ITC-U Software Release v2.2.3

Compared with v2.1.4

Release date: 2023-01-09

Countdown timer for maintenance

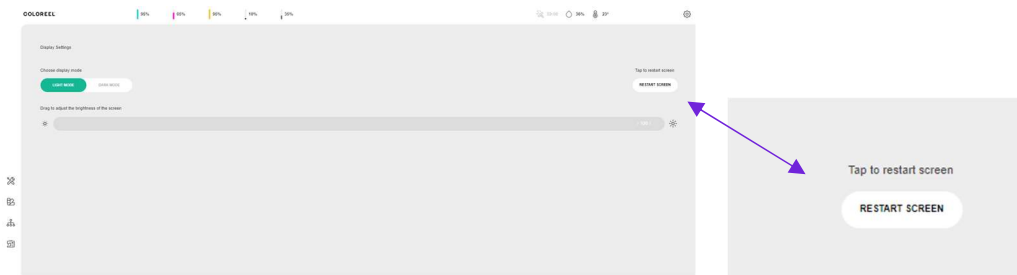
- Added notification if too high thread consumption
- Added button to restart display
- Redundant fixation temperature sensors
- Added timer that counts down the time until critical maintenance
- Temperature and humidity notification hysteresis
- Added slider to set thread length between embroideries
- Updated user interface styling guide to fit languages translations

Language settings and Thread length slider

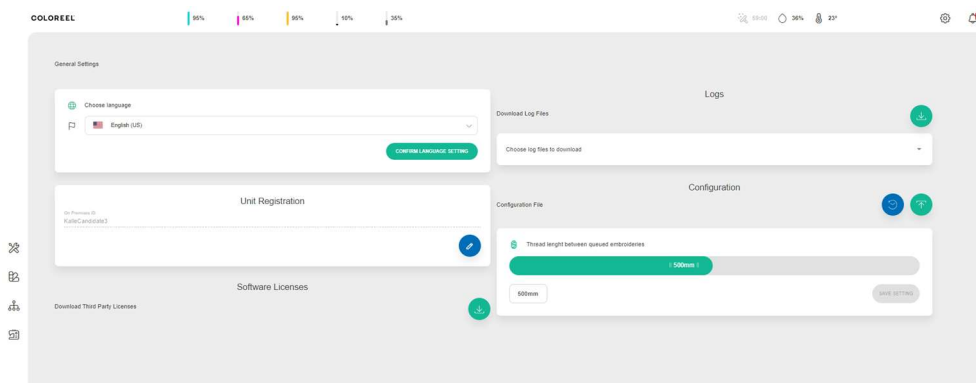
The new ITC-U v2.2 is the first version that support different languages. Introduced languages in the release are English and Spanish. The release also comes with stability and multi head improvements.
